REMARKS

This is intended as a full and complete response to the Office Action dated September 7, 2005, having a shortened statutory period for response set to expire on December 7, 2005. Please reconsider the claims pending in the application for reasons discussed below.

ATTY DKT. No.: APPM/008260/PPC/ECP/CKIM
U.S. SERIAL NO.: 10/680,616 CONF. NO.: 5563
FILED: OCTOBER 6, 2003
APPLICANT: APPLIED MATERIALS, INC.
TITLE: SPIN RINSE DRY CELL
INVENTORS: DONOSO, ET AL.

FIG. 3A

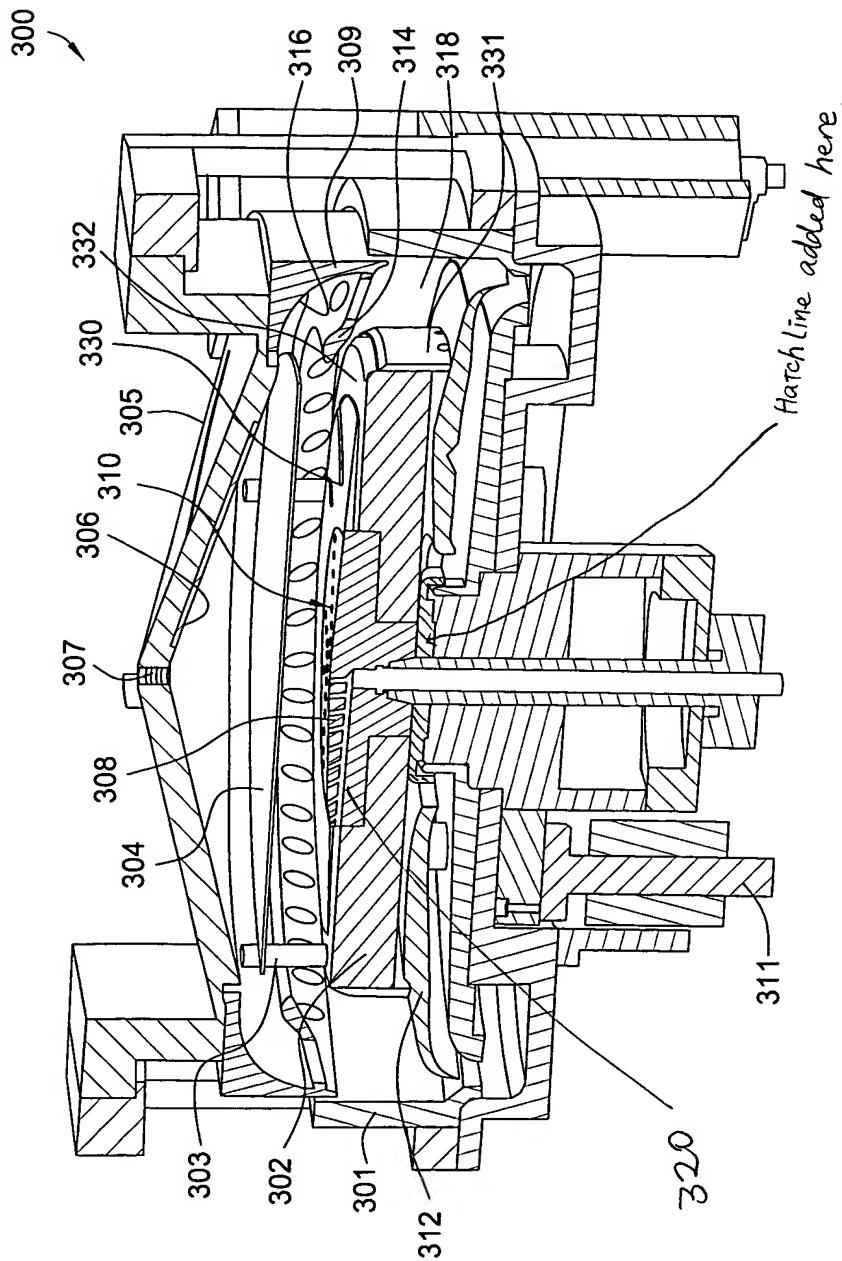
The Examiner objected to Figures 3A-C on the ground that the precise manner in which the rotatable flywheel and central hub interact cannot be clearly determined from the drawings. Applicants respectfully submit that Figures 3A-C are schematic figures which are not intended to show all the details. However, a detailed interaction between the rotatable flywheel and central hub may be found in Figure 5, which is an exploded view of a flywheel assembly of the present invention. From Figure 5, it would be clear to a person skilled in the art that how the flywheel assembly works. Nevertheless, Applicants added reference numerals 521-524 and a short description of the numerals in paragraph [0049] for further explanation.

In Figure 3A, previously omitted numeral 320 and a hatch line have been added. In Figure 3B, a hatch line has been added. In Figure 3C, a hatch line and two arrows have been added. In Figure 5, previously omitted numerals 505, 521, 522, 523 and 524 have been added. In Figure 8, previously omitted numeral 810 has been added and an editorial mistake relates to numeral 839 has been corrected.

FIG. 3B

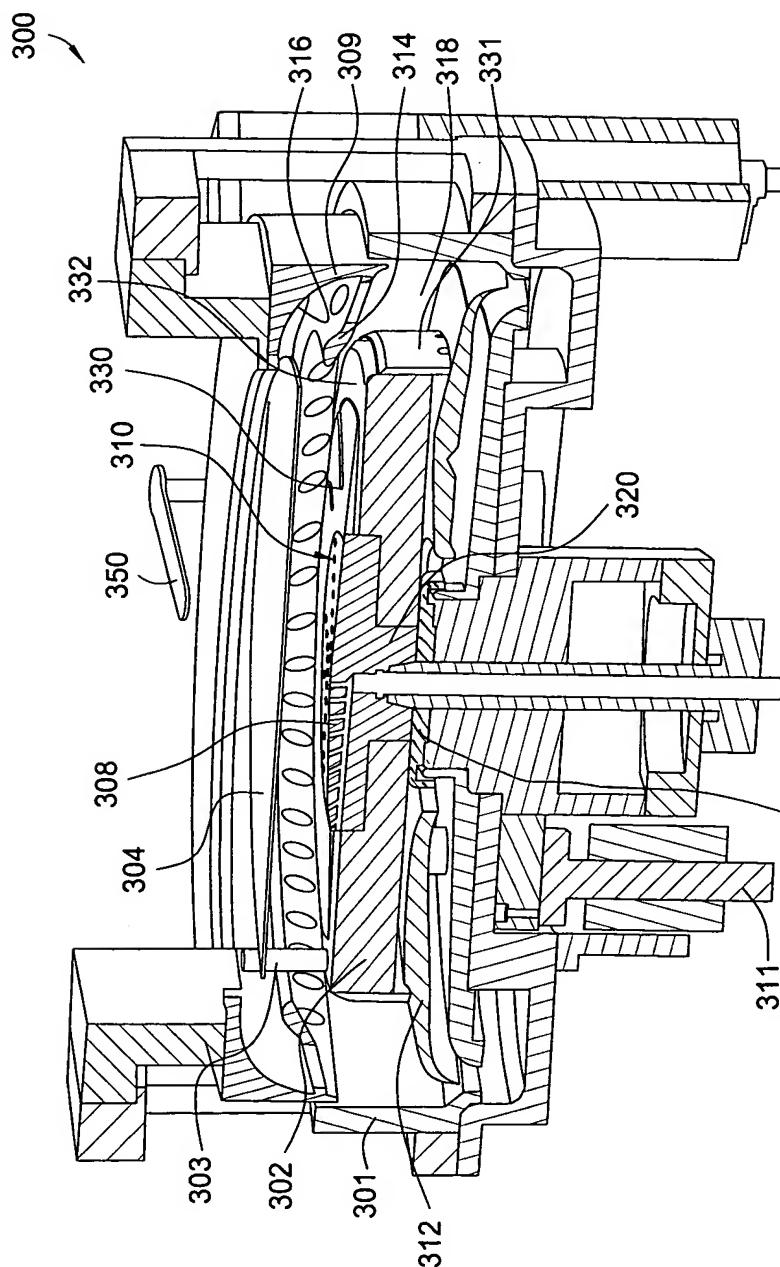
The Examiner indicates that reference number 311 in Figures 3B and 3C is not mentioned in the description. Applicants submit that the number 311 was omitted in paragraphs [0040] and [0048] due to editorial errors and proper amendments have been made to paragraphs [0040] and [0048].

Hatch line added here.

FIG. 8

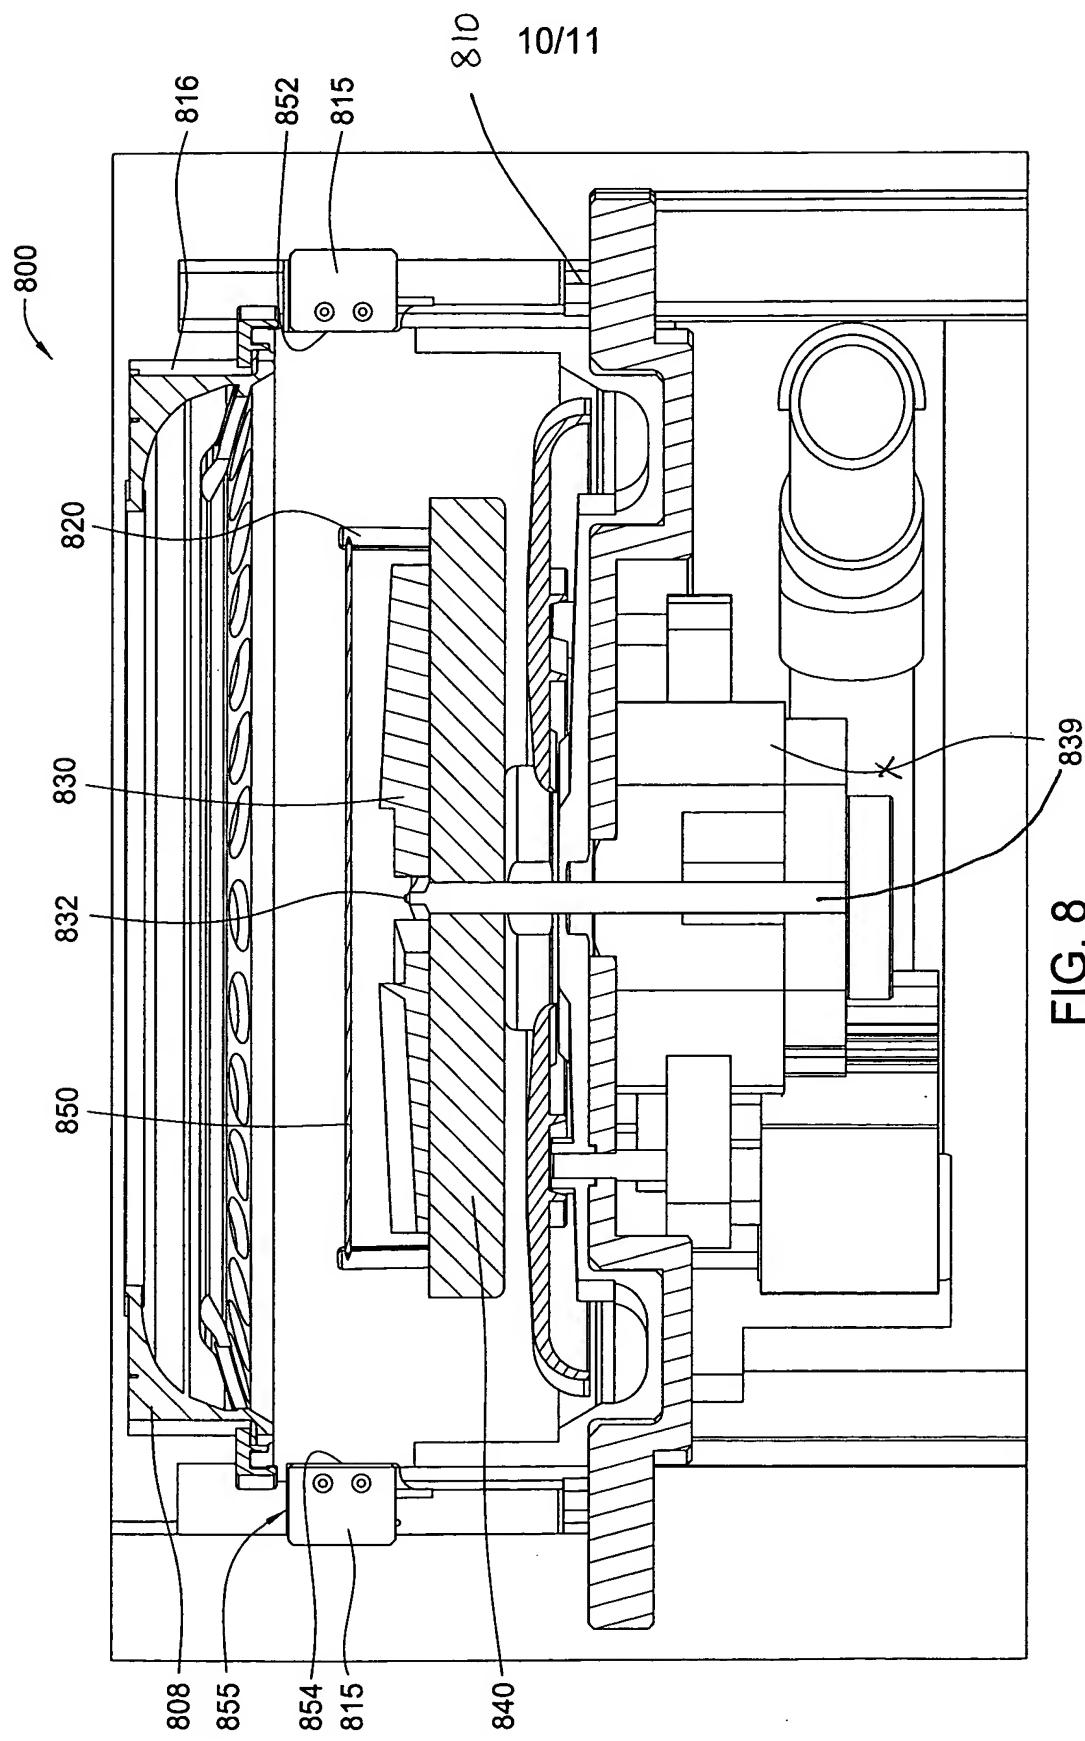
The Examiner further objected to Figure 8 because it looks as if there is no stationary portion. Applicants respectfully submit that Figure 8 has been amended. Element 839 in amended Figure 8 indicates a stationary portion. Additionally, Applicants submit that Figure 8 focuses on the substrate sensing system 855, thus, the substrate movement portion is only schematically shown since more detailed structure can be found in previous figures.
